COMMENTS – UPPER LOWER

COMMENTS – STANDALONE

COMMENTS – INTEGRATED

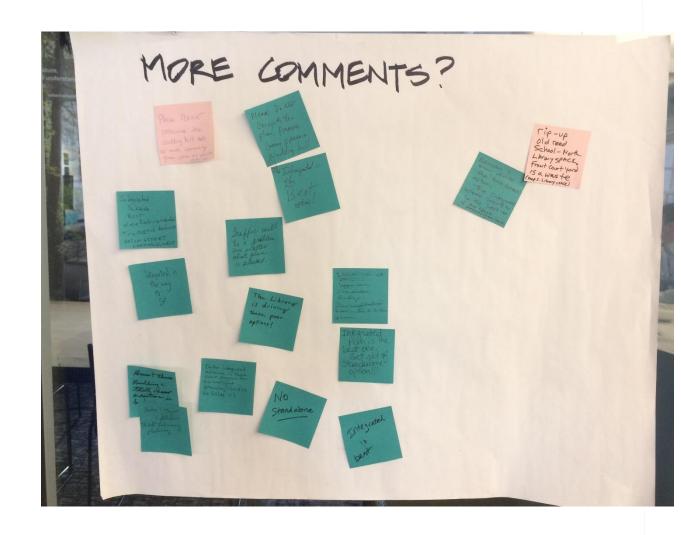
- Takes up too much green space
- Separate structure adds costs for APS not desirable
- Not a good option relative to integrated scheme
- Blocks fields from 18th street
- Large Building on 18th street which ruins sight-lines
- Modify with library to provide integrated solution
- Better use adjacent library
- Too many compromises without enough benefit
- Separate buildings not ideal for staff and students: loss of instructional time

- NO!
- Takes up too much green space
- This is the least desirable option
- Too many people and traffic
- Building takes away park along 18th street and loses young trees
- The building is too large
- The student capacity is too high
- We need seats, 1000+ is good
- Too much traffic for the neighborhood
- Loss of Reed sledding hill is undesirable
- Large building not ideal because of loss of instructional time

- Best option by far
- Great solution for students
- Good idea to preserve park
- Does not maximize seats for Arlington
- This scheme has a good community feel\
- Like the option of building up
- Would be good with a parking garage behind it
- Please consider underground parking option
- 3 story height a concern
- This is the only acceptable option
- Maintains sledding hill
- Smaller footprint best for students

COMMENTS - PARKING

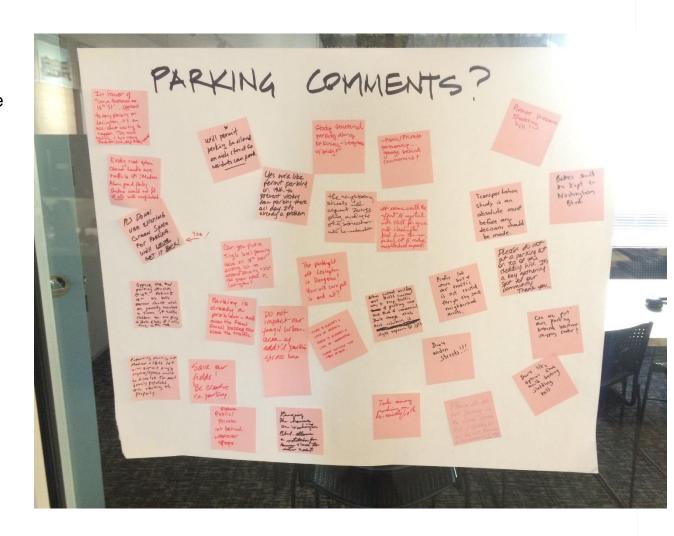
- In favor of larger expansion on 18th St: opposed to parking on Lexington due to safety
- Existing road system can't handle traffic @ 18th and Madison: above ground parking wouldn't fit in neighborhood

- Don't use existing green space for parking: we'll never get it back
- Study structured parking along McKinley
- Opposed to parking structure at 18th and Madison: both narrow streets

- Explore public/private lot behind Westover Shops
- Take away parking on McKinley & 18th
- Can you put a parking lot on 18th over existing lot
- We'd like to permit parking on 19th to prevent visitors from parking there: it's already a problem

- Permit parking on side street so residents can park
- Do not impact our fragile urban area with additional parking stress
- Don't like options that would destroy sledding hill and/or upper field

- Preference given to options that do not route traffic through smaller neighborhood streets
- Transportation study is absolute must prior to any decisions
